**1.2 12-14 JOHNSON STREET, OAKLEIGH
CONSTRUCTION OF A MIXED USE DEVELOPMENT INCLUDING OFFICE AND RETAIL
AND A REDUCTION IN THE STANDARD CAR PARKING REQUIREMENT
(TPA/51498)**

EXECUTIVE SUMMARY:

Oakleigh Major Activity Centre Preferred Building Heights

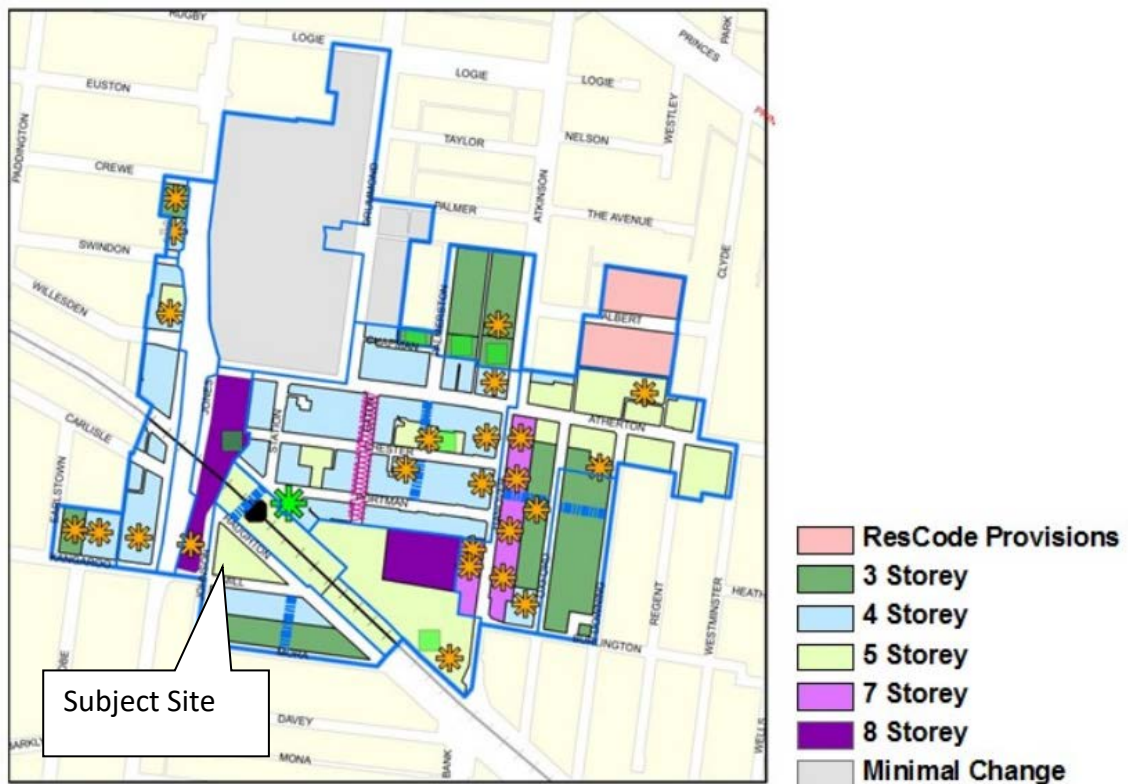
The figure identifies that the car park to the west of the site is a strategic opportunity site, allowing for greater heights (up to 8 storeys) whilst the subject site is the commencement of transition down to the residential area to the south, with a preferred building height of 5 storeys.

For the subject site, the Overlay seeks zero street setback up to a façade height of 12 metres, with building above set back 5 metres from the street up to a height of 17.5 metres (5 storeys).

Precinct 3C Precinct Requirements

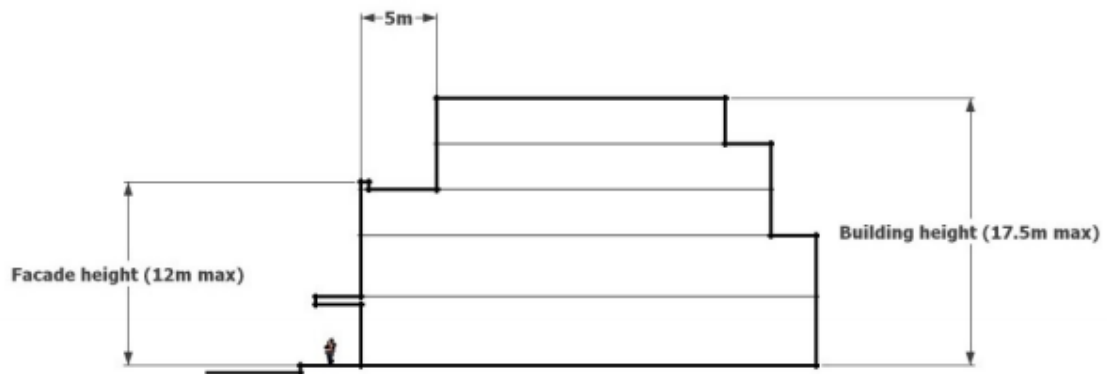
The application seeks to vary all aspects of these preferred design requirements as discussed below.

The proposal seeks construction of a six (6) storey development with a height of 23.2 metres (measured to the roof form) which exceeds the preferred height within the Overlay by 1 storey and 5.7 metres.

It is considered that the height of the building fails to provide an appropriate transition to the adjoining residential area to the south which has a maximum mandatory height of 4 storeys, 14 metres (as prescribed within the General Residential Zone, Schedule 5) for any residential building. It is considered that this storey, in addition to the setbacks proposed fails to provide for an appropriate transition to this adjoining precinct.

The Overlay prescribes a recommended setback of 5 metres from the podium of the upper levels. Variations are sought for both the Johnson Street and Mill Road interfaces.

A setback of 3.7 metres – 4.975 metres is proposed to Johnson Street, which fails to meet the preferred setback requirement. However, the proposed setback will provide a book-end to the Johnson Street interface which is the commercial interface of the site. The northern end of the interface proposes a setback of 4.9 metres which will allow for an appropriate transition from the adjoining property

The interface to Mill Road is more sensitive and policy seeks to provide a moderated interface to scale down to the residential area on the opposite side of Mill Road. A setback of 4 metres is proposed. The development plans suggest that the adjoining property would also provide for a setback of 4 metres to this interface at the upper levels. The Overlay requires a setback of 5 metres to provide an appropriate transition to this interface, and also provide for a strong three storey form with recessed upper levels. The applicant has also relied on this decreased setback to help mask the appearance of the sixth floor and the excess height proposed. Therefore this variation is not supported for both reasons.
